Preliminary Consultation  
10918 Montrose Avenue  
Garrett Park Historic District

HISTORIC PRESERVATION COMMISSION STAFF REPORT

Address: 10918 Montrose Avenue	Meeting Date: 11/16/94
Resource: Garrett Park Historic District	Preliminary Consultation
Case Number: N/A	Tax Credit: No
Public Notice: 11/02/94	Report Date: 11/09/94
Applicant: Charlene Sussel	Staff: Patricia Parker
PROPOSAL: Addition	RECOMMEND: Proceed to HAWP

FRONT ELEVATION

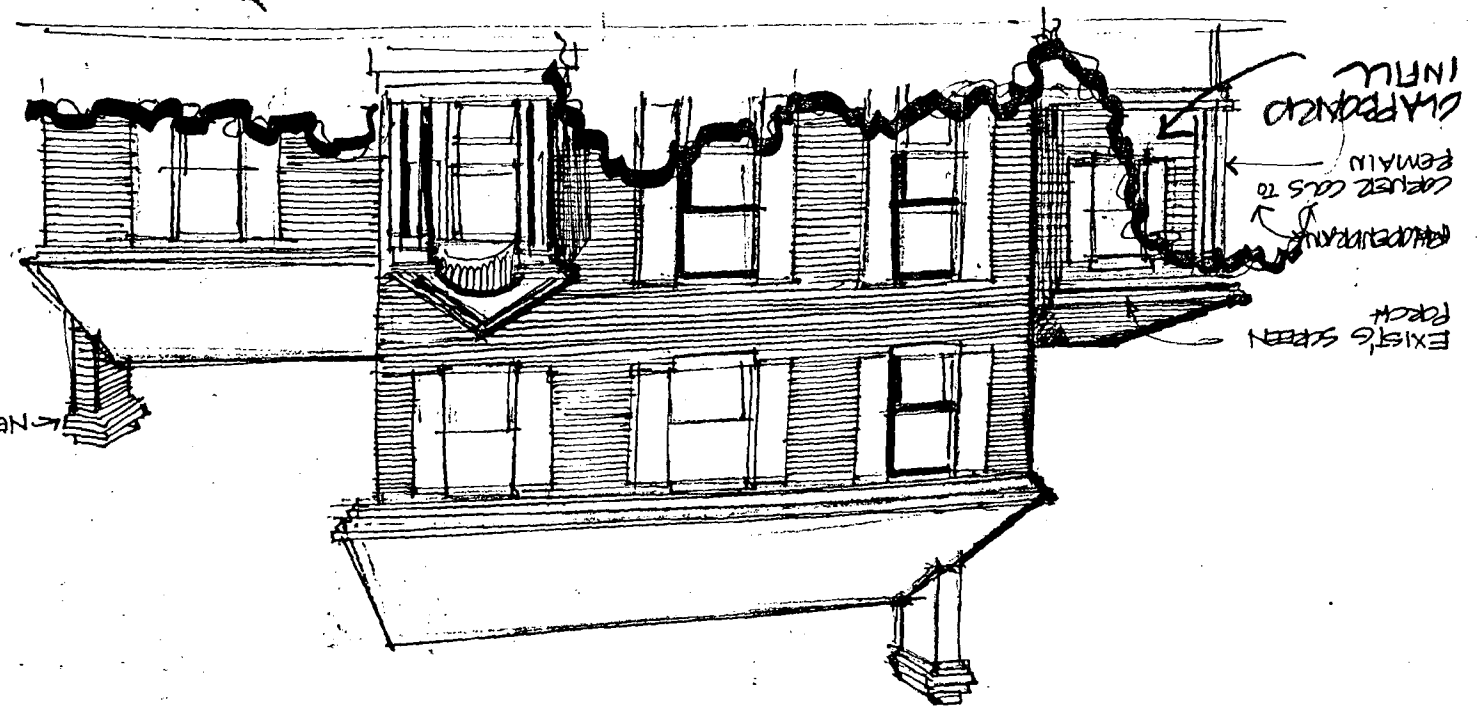
The applicant proposes to enclose the existing side porch using clapboard as in-fill. That is, the existing columns and

upper structure would remain. Four window would be created. Staff suggests that these openings should be true-divided light of the same configuration as the window of the appendage at the north end of the structure. Staff feels that, although this change would be visible from the streetscape, that the scale and mass of the resource is not significantly altered. The in-fill addition, located very close to the adjacent property to the south, would provide privacy not available in the porch of the existing structure. Also, the use of clapboard, instead of brick, would be less weighty. No shrubs or trees would be involved in this proposal.

The applicant proposes a new brick chimney to be constructed at the end wall of the north facade of the structure. Staff does not find this proposal problematic. The existing appendage is one-story and therefore, the external brick chimney with brick cap would be lower than one located in the main section of the structure. No tree/shrub removal is involved.

SKETCH OF NEW ADDITION

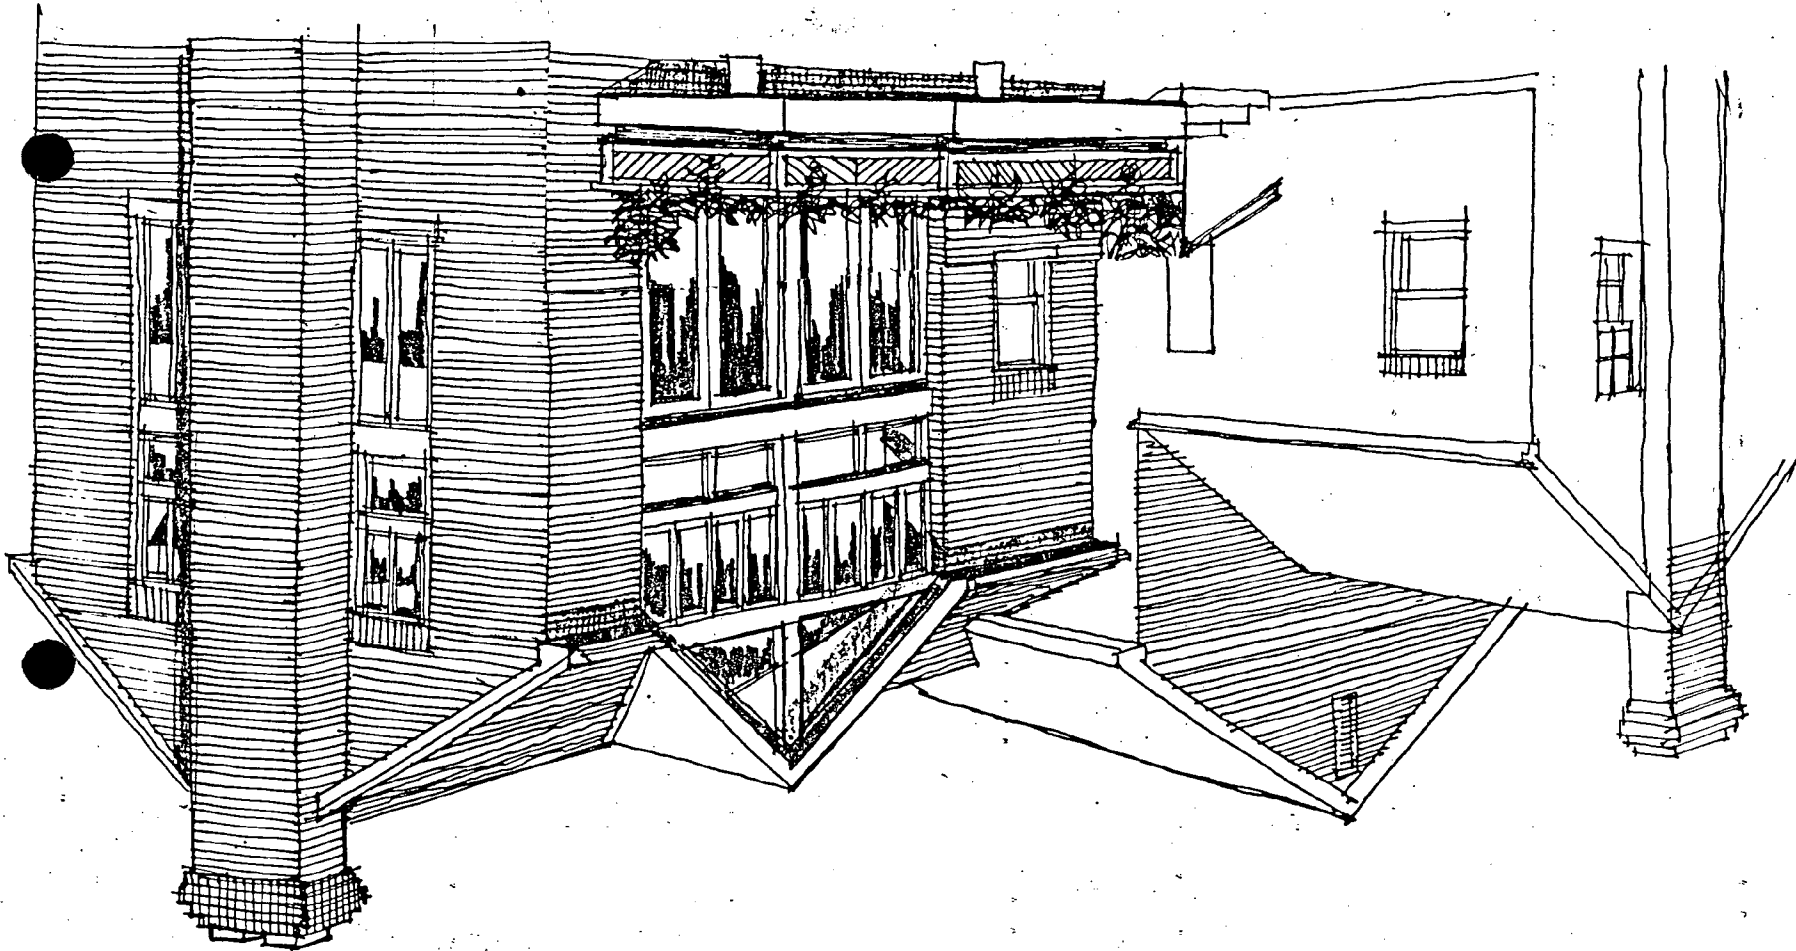
The applicant proposes a brick two-story addition with endwall external chimney and open wood decking. This substantial change, as proposed, would be lower than the roofline of the existing structure, totally contained in the rear of the property, indented from the side wall and facing a very wooden section of an expansive sideyard. The architect proposes a large expanse of glass through a combination of openings to access the deck. Staff feels that the window opening closest to the existing structure should be true divided light and of a similar configuration as those present. Staff does not find other openings on the first and upper story to be problematic.

Staff feels that greater design freedom may be utilized as the addition does not affect the streetscape. Staff would recommend the use of slate or good quality asphalt shingle roofing. No tree/shrub removal is involved.
